**SHARON DEPARTMENT OF PUBLIC WORKS  
TOWN OF SHARON, MASSACHUSETTS  
WELLS 2, 3, AND 4 WATER TREATMENT PLANT  
CONTRACT NO. 2025-101 (DWSRF #12443)**

**ADDENDUM NO. 2**

**May 10, 2024**

**WALL PANEL HORIZ. JOINT DETAIL & GENERAL METAL BUILDING NOTES**

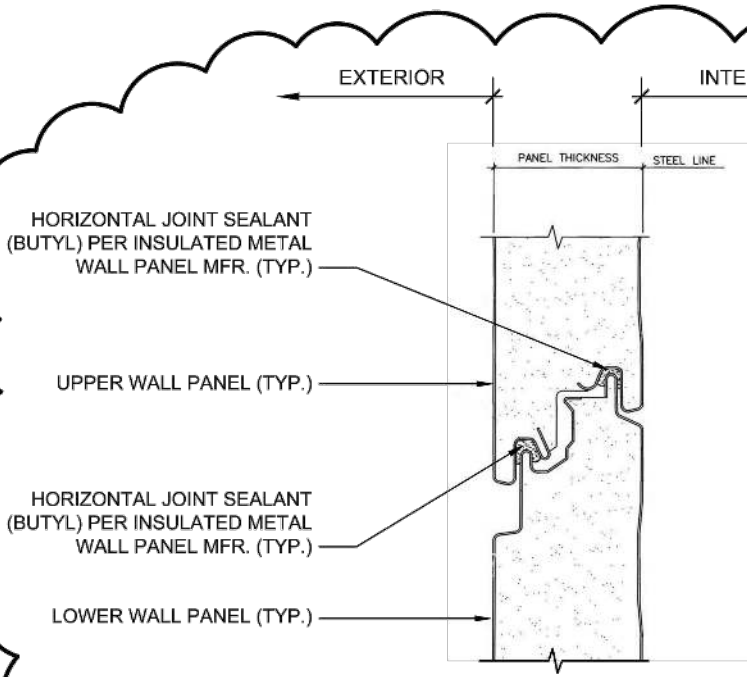
- Add *Detail 21 – WALL PANEL HORIZ. JOINT DETAIL & GENERAL METAL BUILDING NOTES* per Attachment 3, Sheet SKA-6.

1. THE METAL BUILDING MANUFACTURER AND INSTALLER ARE RESPONSIBLE FOR COMPLIANCE WITH CODE-REQUIRED AIR BARRIER PERFORMANCE.
2. SUBMIT SHOP DRAWING DETAILS SPECIFICALLY ILLUSTRATING CONTINUITY OF AIR BARRIERS, INCLUDING BUT NOT LIMITED TO SEALANTS AND AIR BARRIER MEMBRANES SHOWN IN THE BID DOCUMENTS.
3. SUBMIT SHOP DRAWING DETAILS ILLUSTRATING MANUFACTURER'S RECOMMENDED TREATMENT OF METAL TRIM LAP JOINTS.
